**Technical Service
Information Bulletin**

TILT/TELESCOPIC STEERING NOISE/ SMOOTHNESS IMPROVEMENT

'99 LS 400

STEERING
ST003-99

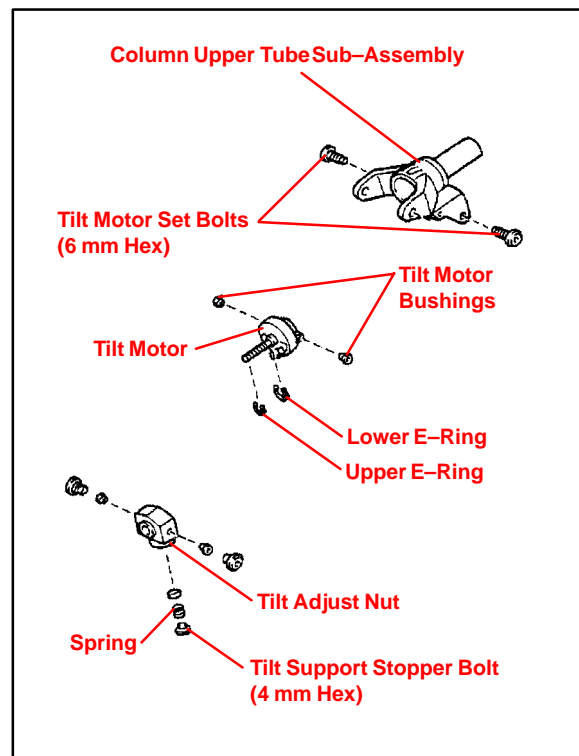
STARTING VIN	PRODUCTION CHANGE
JT8BH28F * W0145000	Tilt Motor Set Bolts changed to improve Tilt Motor alignment.
JT8BH28F * X0166329	Tilt Motor, Telescopic Motor & Tilt Stopper Spring have been changed.

- Disconnect the Tilt Motor Electrical Connector.
- Remove the 2 Tilt Motor Set Bolts.
- Move the Tilt Motor downward to remove it from the Column Upper Tube Sub-Assembly.

- Loosen the Tilt Stopper Support Bolt.
- Remove the Upper E-Ring at the end of the Tilt Motor Shaft.
- Tilt the Column Upper Tube Sub-Assembly upward and carefully unthread the Tilt Motor from the Tilt Adjust Nut.

- Install a new Lower E-Ring on the new Tilt Motor and lubricate the Tilt Motor Shaft with molybdenum disulfide lithium grease.
- Thread the new Tilt Motor into the Tilt Adjust Nut and install a new Upper E-Ring on the end of the Tilt Motor Shaft.

- Install 2 new Tilt Motor Bushings in the new Tilt Motor Housing and align Column Upper Tube Sub-Assembly with the Tilt Motor Housing bolt holes.
- Carefully insert 2 Tilt Motor Set Bolts into the Tilt Motor. Tighten the Tilt Motor Set Bolts evenly in 2-turn
